7 February 2025

**Our Ref:** H-24034

**RE: RESPONSE FOR REQUEST FOR INFORMATION - HERITAGE MATTERS  
DA2024/1375 FOR INTERNAL AND EXTERNAL ALTERATIONS AND ADDITIONS TO MANLY WHARF  
AND MANLY WHARF HOTEL AT MANLY WHARF RETAIL EAST ESPLANADE MANLY**

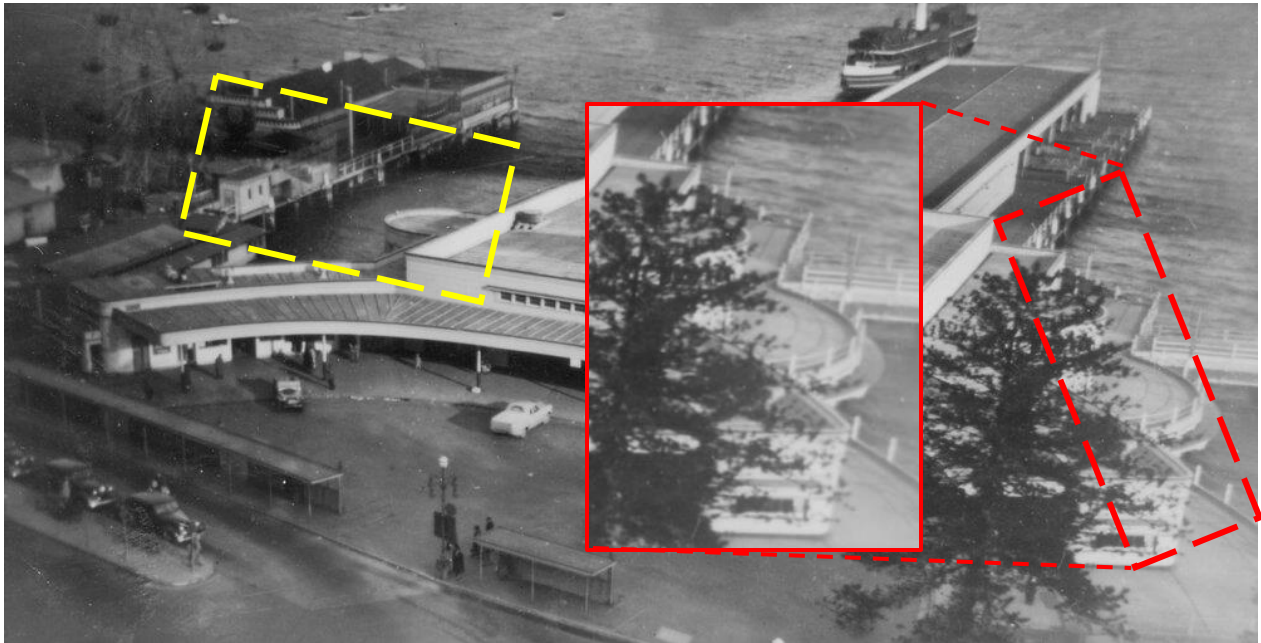
- 1. Horizontal railings are typical of Sydney wharf and ferry infrastructure in terms of level of safety and aesthetic character and without substantial justification it is unlikely the removal of the existing balustrades to the east and west boardwalks described in the SHR 01434 listing as metal 'ship' railing, and replacement with the proposed glass balustrade will be supported. Further details outlining the heritage significance of the existing metal railings to the outer edge of the boardwalks as well as defining dining areas is to be provided.*

Likewise, a comparison of historical photography indicates that the existing metal wharf balustrade is not original fabric. Photographs of the wharf from 1951 (Figure 1), the 1970s (Figure 2) and 1980s (Figure 3) shows the western balustrade to be a timber balustrade. This balustrade was replaced with the retail addition works to the wharf in 1990, as evidenced in the photograph dated 1 December 1990 (Figure 4), which shows the metal balustrade to be the same as that which is currently on site (Figure 5).
